Well Name: GALLEGOS CANYON

Well Number: 77 Type of Well: CONVENTIONAL GAS

Type of Submission: Subsequent Report Type of Action: Plug and Abandonment

Subject:
 RE: [EXTERNAL] GCU 077 (3004508235) - CBL

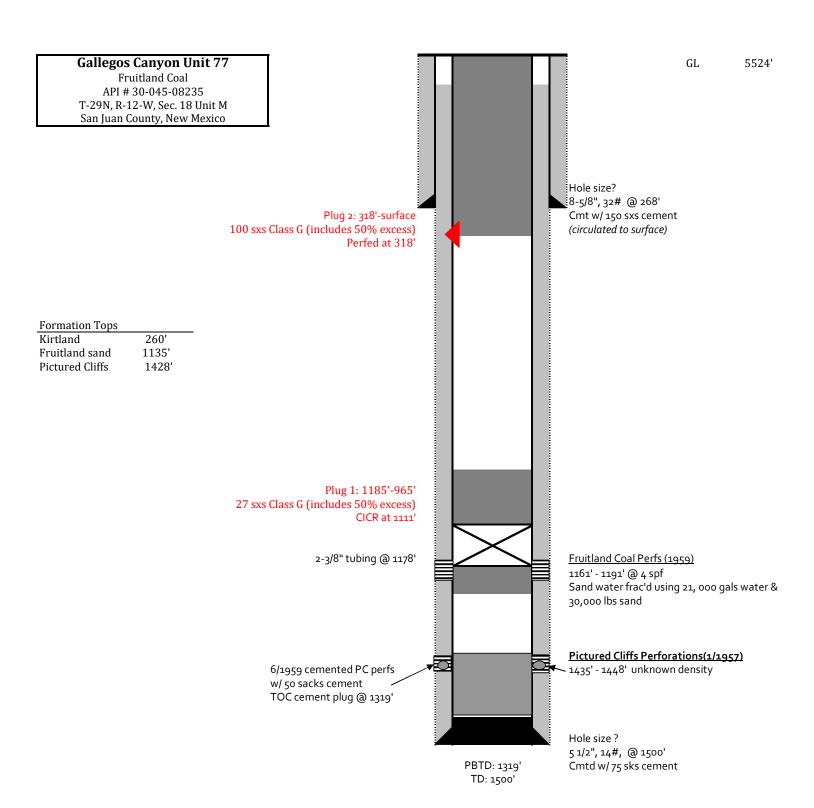
Yesterday, we rigged up on the GCU 077 to begin P&A operations. After setting our CR, we got a good pressure test on our casing. Attached is the CBL ran this morning. We propose setting an inside plug on bottom from 1185' (per NMOCD) to 1055' (per BLM). Then, we propose perforating at 318', establish circulation up the bradenhead with water, and then bullhead our cement down the casing and up the bradenhead for our surface plug. Please let me know if you are good with this plan and have any questions

After further review - which I was able to get Brandon's opinion – we believe they can go ahead with the procedure as is - perforating at 318 feet and bring cement to surface - there is no water at that point to contaminate.

The BLM concurs with NM OCD on the requested procedure.

NMOCD would like Simcoe to perforate at 354 or 352 and run a plug inside outside to 300 reverse out at 300– have the bradenhead open during the running of the plug and then woc with bradenhead open for 4 hours then shut for 2 hours and see if we have pressure prior to going into the surface pipe – can discuss further after the 2 hour shut in.

The BLM finds the procedure appropriate.
